A-579927

ISSUE 12

660 A TYPE TELEPHONE SET CONNECTING DIAGRAM

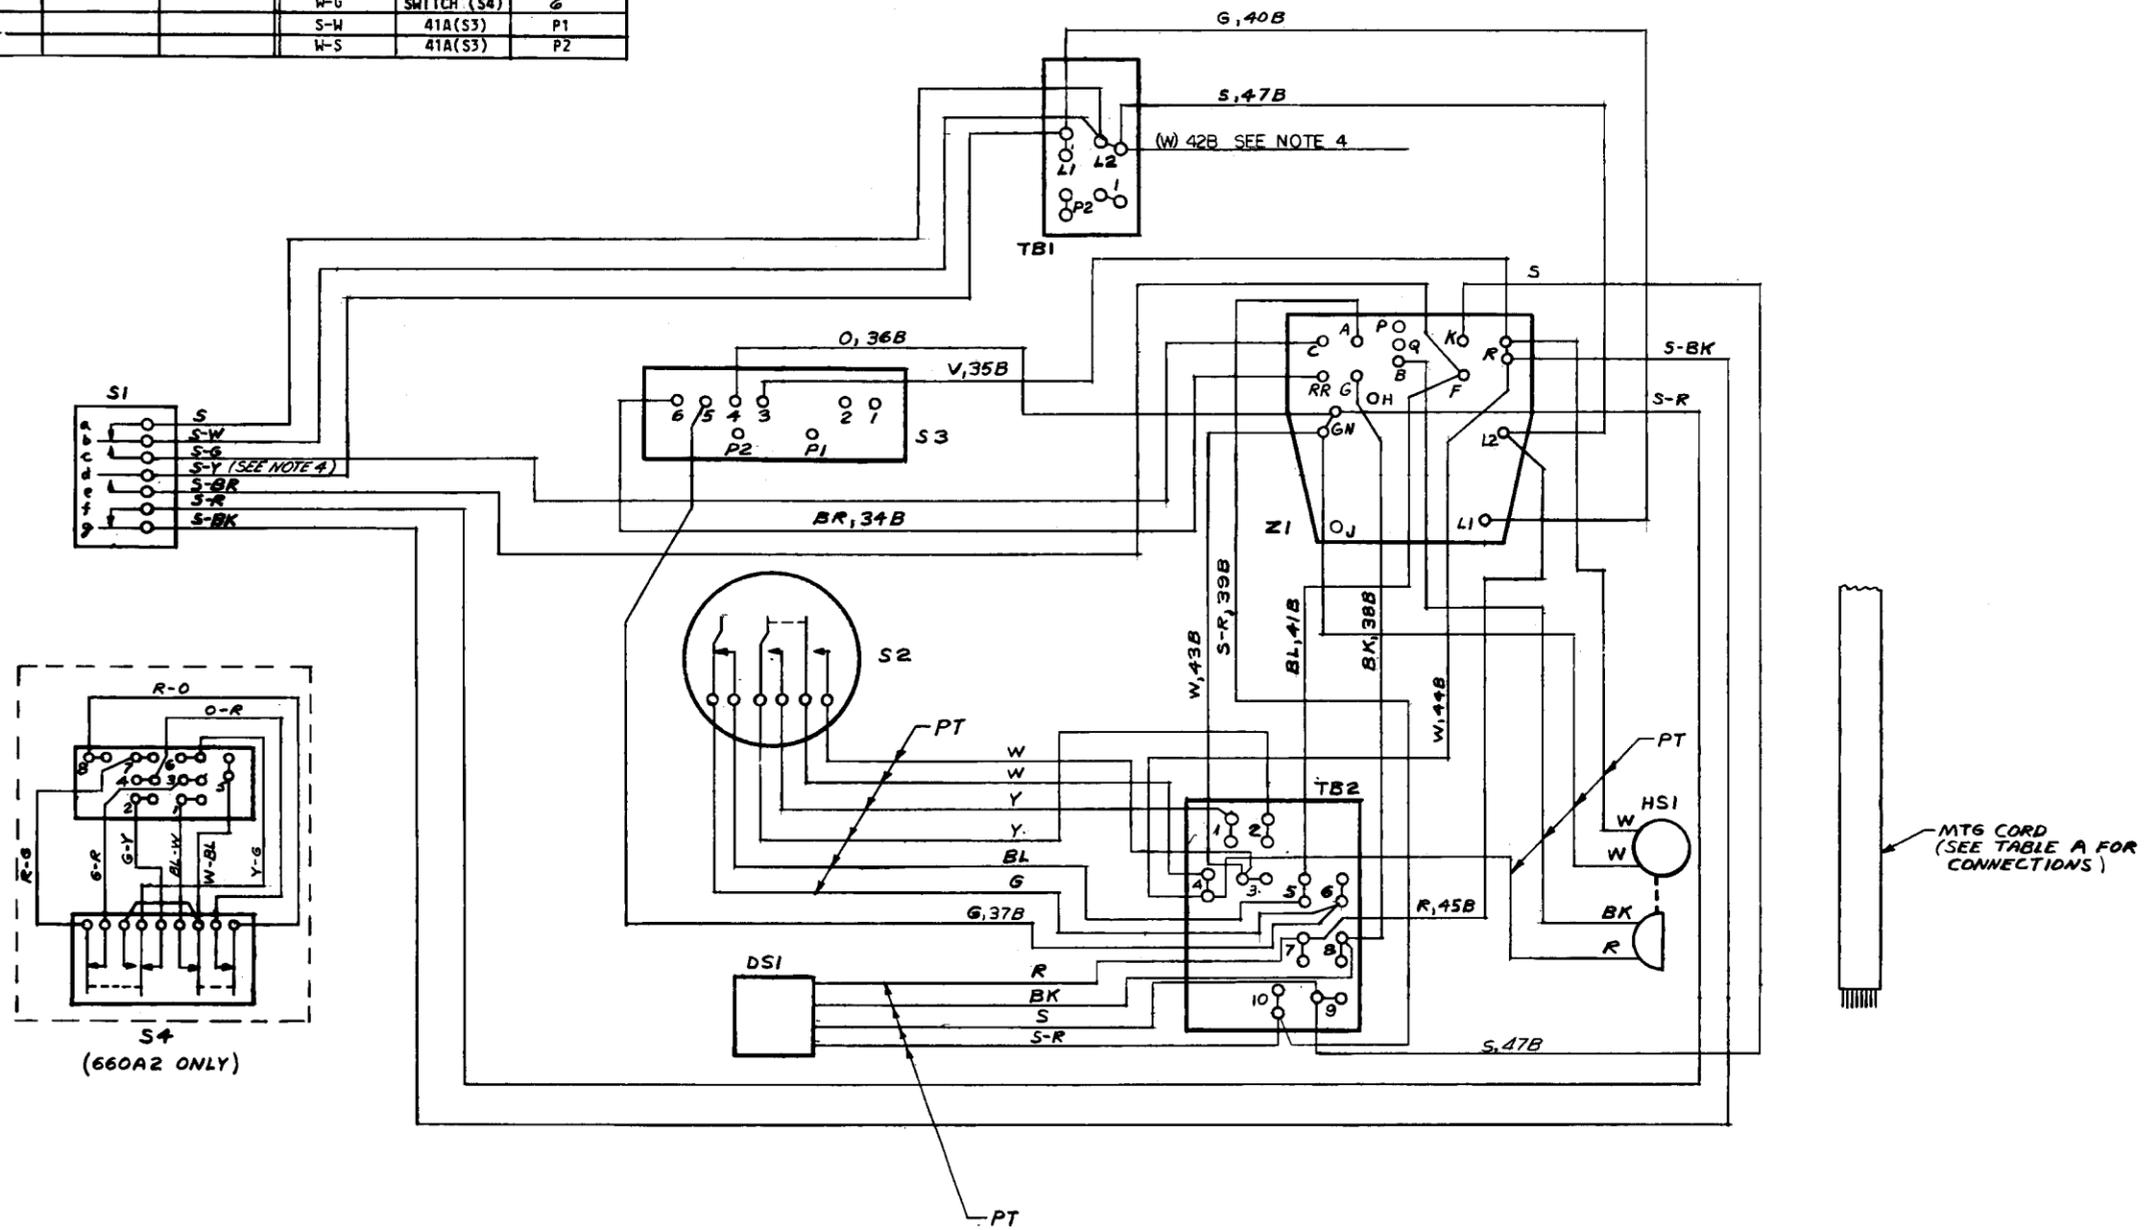
CHANGED: IN NOTE 4 PART B 2 OF S4 - WRS \* 10/54

CHANGED: REF. TO NOTE 4 AT S1 WAS TO S-G LEAD

CHANGED: TERM DESIGNS 3&4 OF TB2 WERE INTERCHANGED; W, 44 B & R LEADS CONN TO BOTTOM TERM 4 OF TB2 WERE CONN. TO RT HAND TERM 3; W LEAD CONN. TO TOP TERM 4 OF TB2 WAS CONN. TO LEFT HAND TERM 3. W, 43 B & W LEADS CONN. TO TERM 3 OF TB2 WERE CONN. TO TOP & BOTTOM OF TERM 4 RESP; R LEAD CONN. TO TOP TERM 7 OF TB2 WAS CONN. TO BOTTOM TERM 7; BK LEAD CONN. TO TOP TERM 8 OF TB2 WAS CONN. TO BOTTOM TERM 8; TERM DESIGNS 9 & 10 OF TB2 WERE INTERCHGD.; S-R, 39B & S-R LEADS CONN. TO TERM 10 OF TB2 WERE CONN. TO LEFT HAND TERM 9 RESP; S, 47B & S LEADS CONN. TO TERM 9 OF TB2 WERE CONN. TO TOP & BOTTOM OF TERM 10 RESP

CHANGED: IN TABLE A, W, 43 B FOR (W) LEAD WAS TB1 B. 66AF WAS DELETED. (W), 42B LEAD WAS SHOWN CONN. T P2 OF TB1 TO T P2 OF S3 WITH REF TO NOTE 4.
